Model: Ti-P1		Date: 21-May-13	No.: RM109001
Subject: IEEE802.11 Interface Unit Type O Notification		Prepared by: Y. Suzuki	
From: 3rd Tech Service Sect.,MFP/P Tech Service Dept.			
Classification:	<input checked="" type="checkbox"/> Troubleshooting <input type="checkbox"/> Mechanical <input type="checkbox"/> Paper path <input type="checkbox"/> Product Safety	<input type="checkbox"/> Part information <input type="checkbox"/> Electrical <input type="checkbox"/> Transmit/receive <input type="checkbox"/> Other ()	<input type="checkbox"/> Action required <input type="checkbox"/> Service manual revision <input type="checkbox"/> Retrofit information <input checked="" type="checkbox"/> Tier 2

Important Notice about the IEEE802.11 Interface Unit Type O

Model: Ti-P1	Date: 05-Jun-13	No.: RM109002h
--------------	-----------------	----------------

Subject: Firmware Release Note: Engine		Prepared by: H. Kobayashi	
From: 2nd Tech Service Sect., MFP/Printer Tech Service Dept.			
Classification:	<input type="checkbox"/> Troubleshooting <input type="checkbox"/> Mechanical <input type="checkbox"/> Paper path <input type="checkbox"/> Product Safety	<input type="checkbox"/> Part information <input

Plain Shaft Bearings

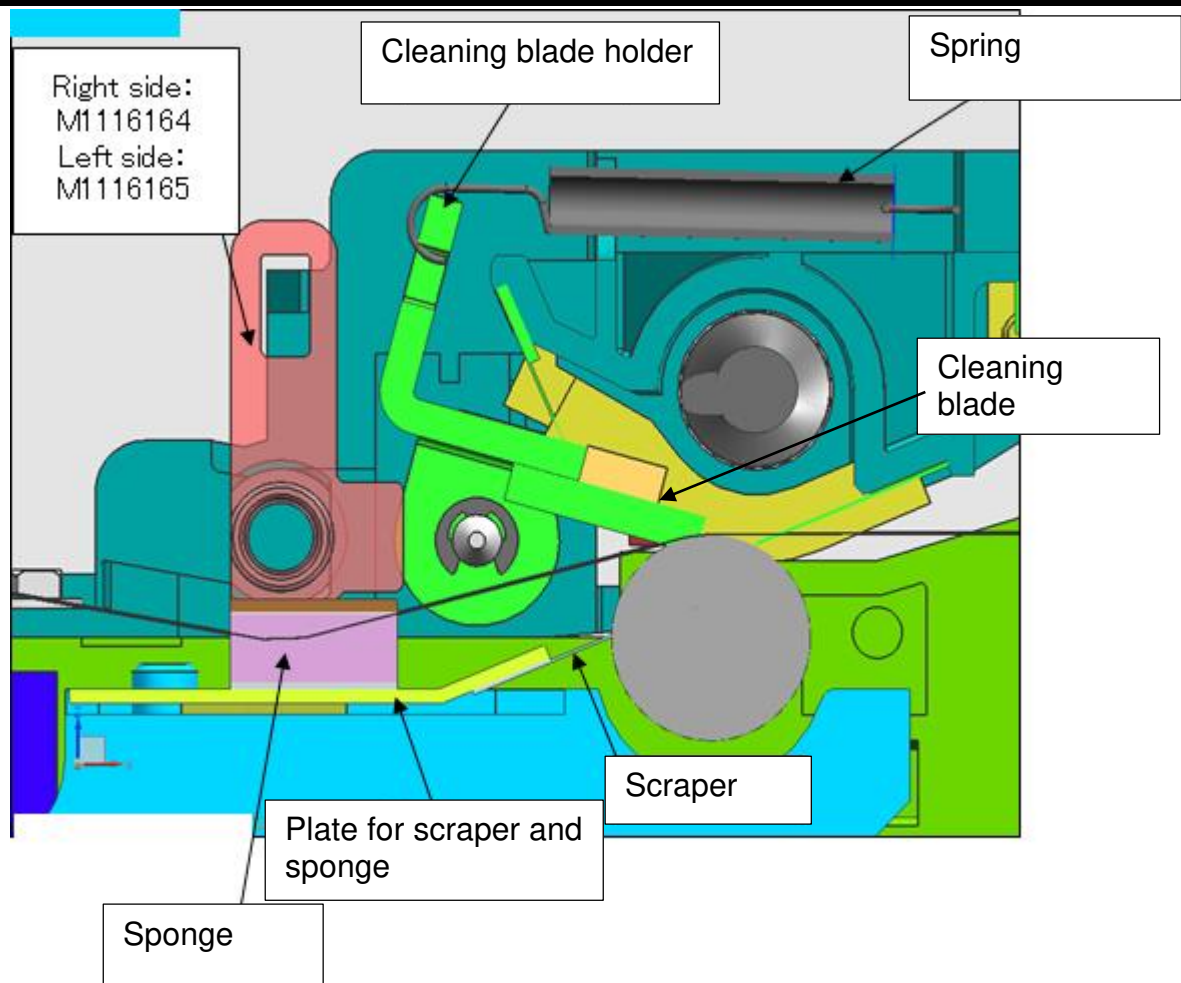
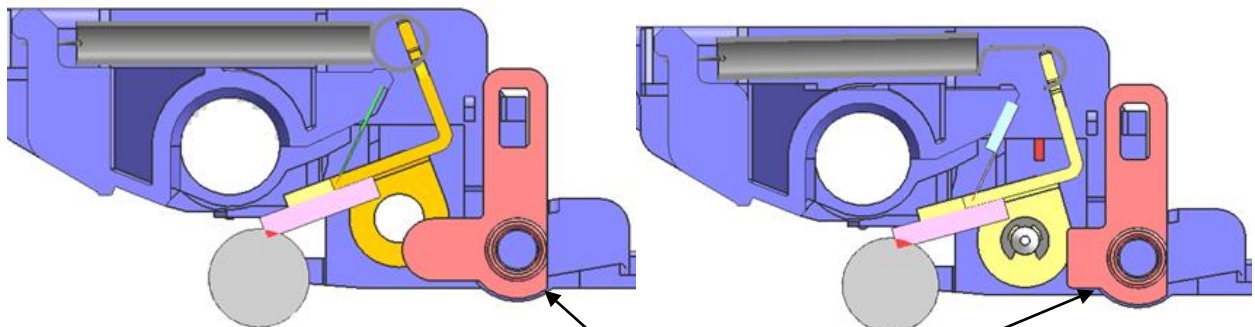
- The material of the cleaning blade was changed.
- The strength of the spring that applies pressure to the cleaning blade was increased.
- The shapes of Plain Shaft Bearings were changed.
- A scraper for cleaning the roller that faces the opposite side of the cleaning blade in the ITB was added.
- A sponge for cleaning the reverse side of the ITB was added.

Reason: To increase the cleaning ability of the ITB unit.

1. There is no interchangeability (**X/X**) between the old and new ITB Cleaning Sub-unit. The old part is no longer available, as a mold is not used to produce the new part. When the old ITB Cleaning Sub-unit has to be replaced, replace it with the new ITB unit assembly.
2. The old Plain Shaft Bearings are still available as a service part for older machines.

Entrance duplex transport roller

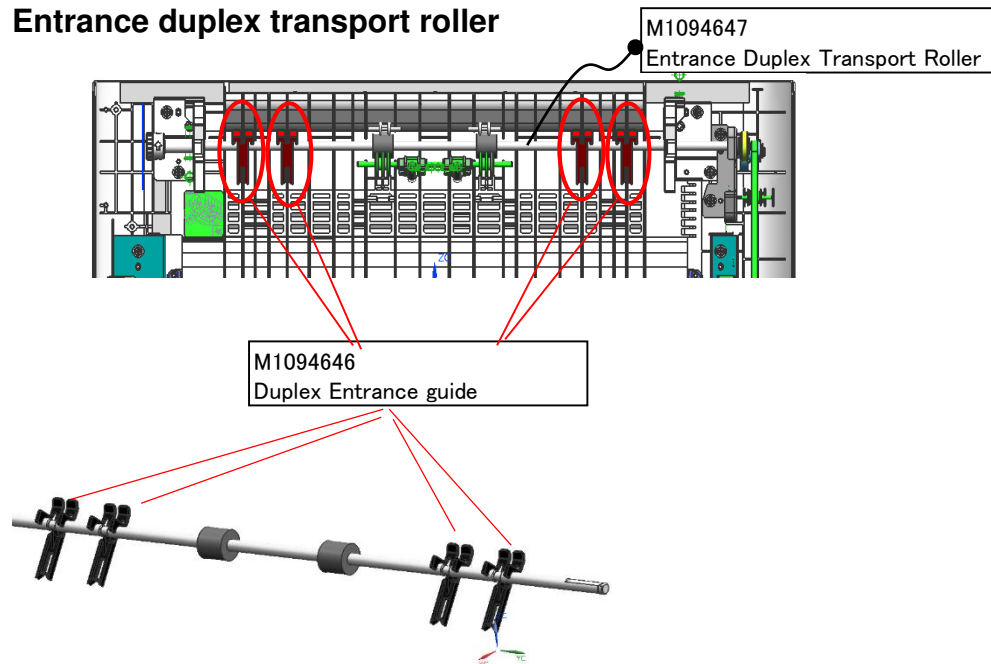
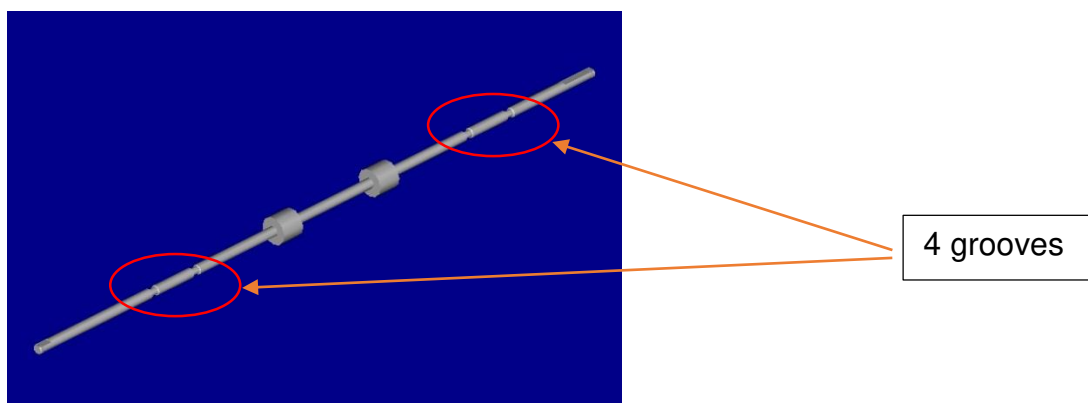
- Four entrance duplex guides were added to the entrance duplex transport roller.
Note: To facilitate this change, four grooves were cut into the shaft of the roller.
- Two sheets (right/left) were added to the lower transport guide plate.
- Two sheets were added to the connecting transport roller guide plate.

Note: It is not necessary to replace the old entrance duplex transport roller when installing these guides.

Terminal Holder

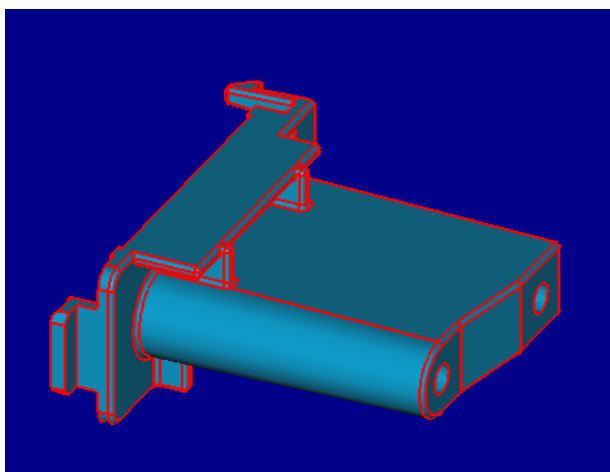
Change: The diameters of the Compression Springs and Terminal Holders were increased.

Compression
Spring:
Diameter:
 $5.8+0.1/0$ to
 $6.1+0.4/0$

Important: There is no interchangeability (**X/X**) between the old and new parts. When the old part needs to be replaced, make sure to replace it with the new parts listed in the table **together as a set**.

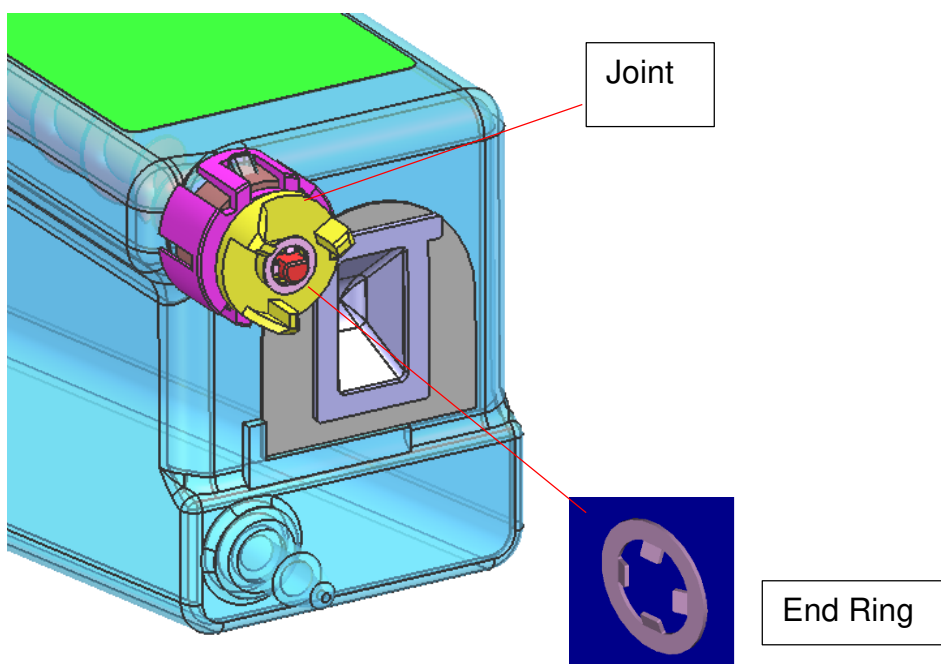
Change: An End Ring was added to the Waste Toner Bottle as a joint stopper.

Reason: To ensure that the joint stays intact even if the bottle is dropped or thrown with force during transport.

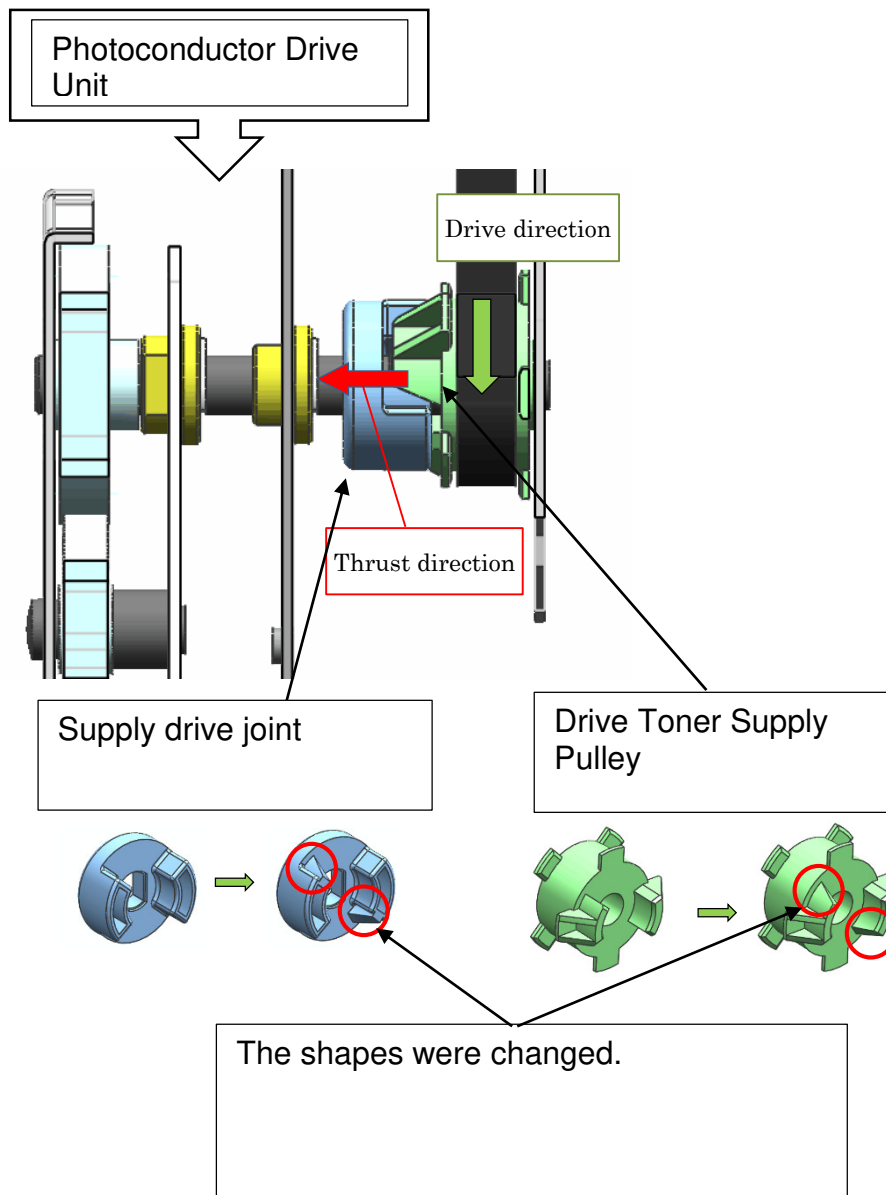
Change: The shapes of the Drive Toner Supply Pulley and the supply drive joint in the Photoconductor Drive Unit

Reason: To reduce the noise between the Photoconductor Drive Unit and Drive Toner Supply Pulley

There is no interchangeability (**X/X**) between the old and new parts. When the old part needs to be replaced, make sure to replace it with the new parts listed in the table **together as a set**.

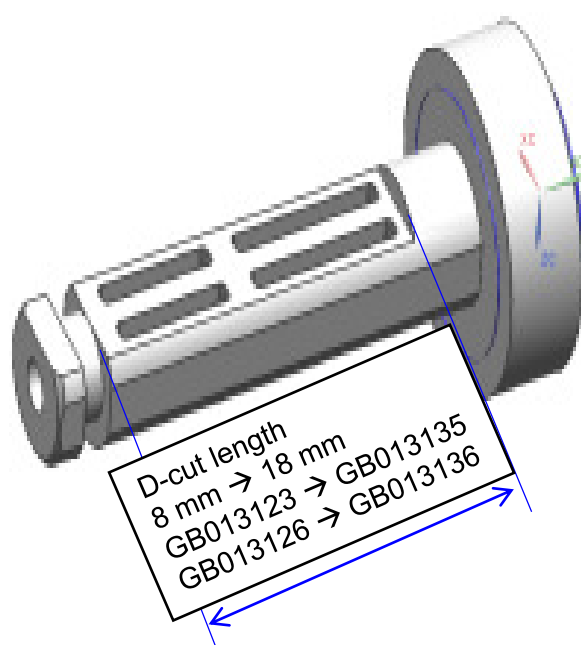
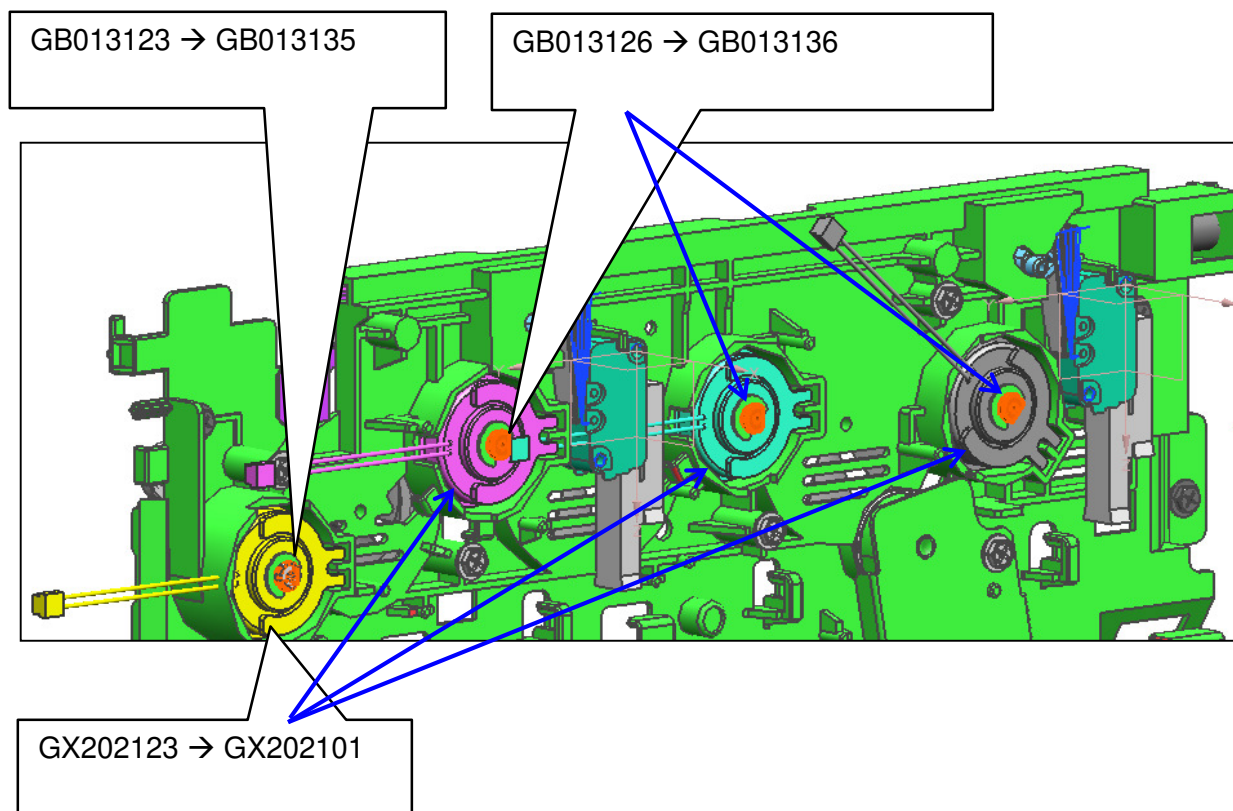
Change: The vendor of the toner supply clutch changed. The length of the D-cut on the supply gear was extended from 8 mm to 18 mm to prevent the clutch from interfering with the supply gear when assembling the clutch and gear.

There is no interchangeability (**X/X**) between the old gear and the new clutch. When the old clutch needs to be replaced, make sure to replace it with the new clutch and new gear listed in the table **together as a set**.

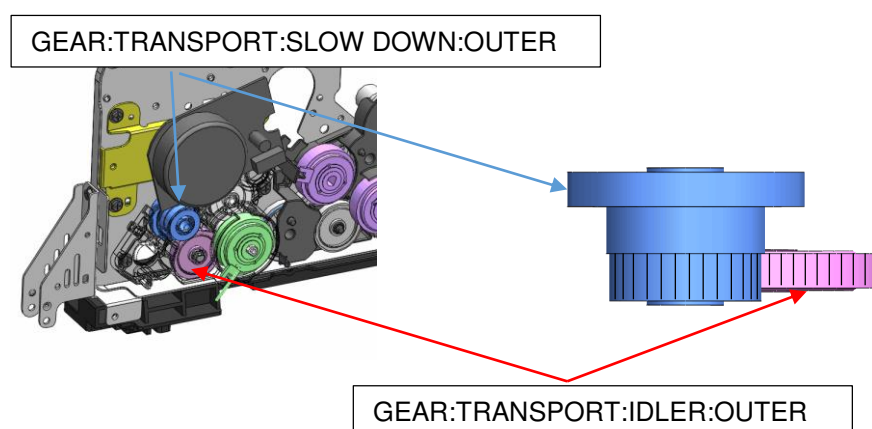
Changes: A stopper ring was added to the Connecting Transport Shaft. The height of the Outer Slow Down Transport Gear was decreased by 2 mm. The shape of the Transport Bracket was changed for assembling.

Reason: To reduce noise caused by interference between the Outer Slow Down Transport Gear and the Outer Idler Transport Gears
